SUPPLEMENTAL BID BULLETIN NO. 1

Construction of Hatchery Building with Insulated Roof, Cemented Posts and Floor, Full-Capacity Solar Power Electrical System, Electricity and Lighting Fixtures and Foundational Water Piping Layout and Closed Room Allocation for Laboratory

URS-26-02-073

February 18, 2026

A-1
PROPOSED FLOOR PLAN
1 | 1 SCALE 1:75 MTS.

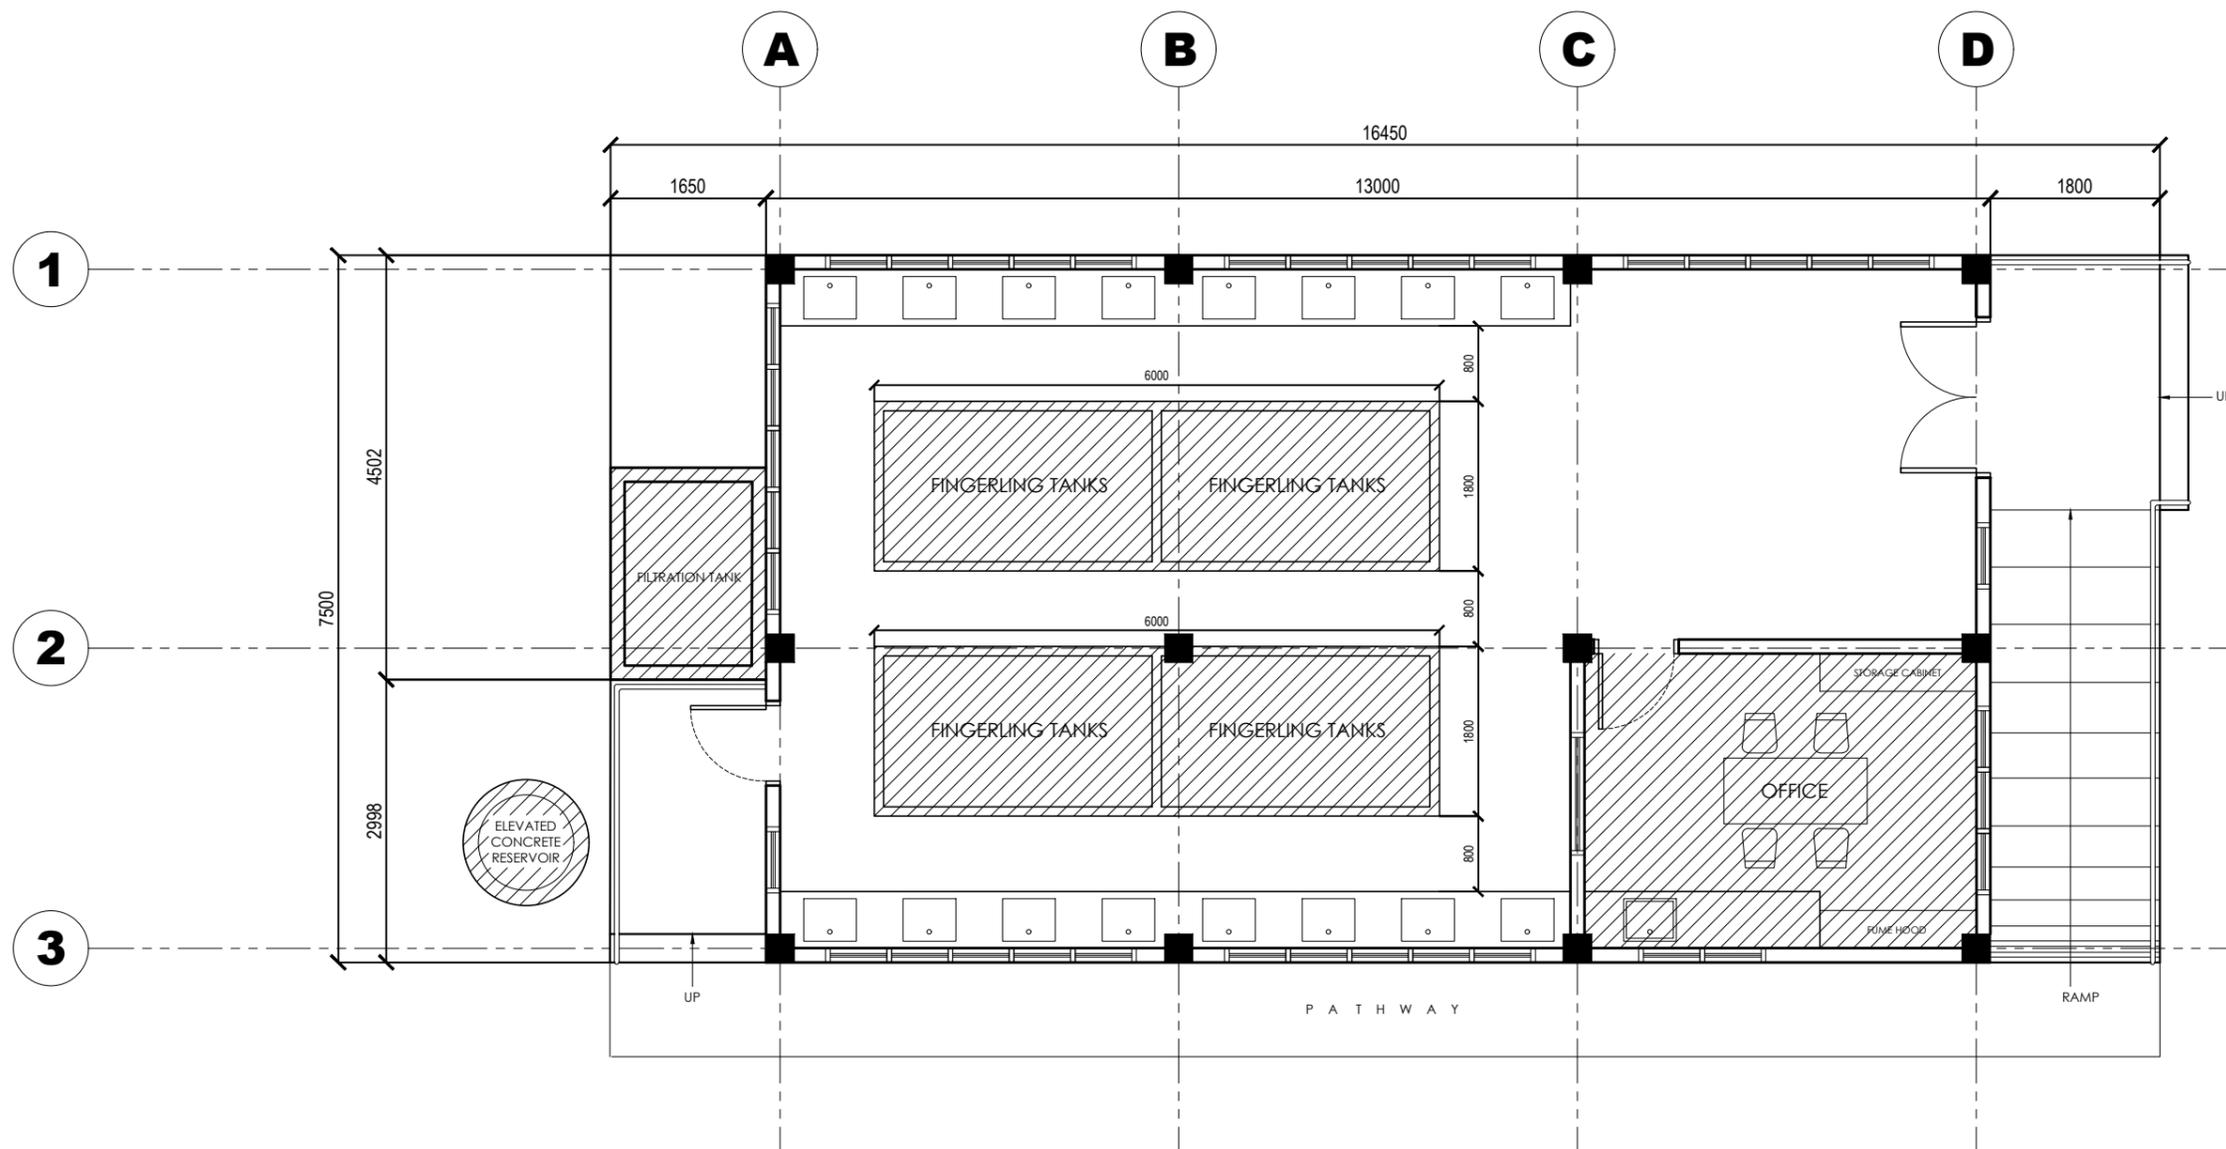
Section VII. Drawings

(See attached file)
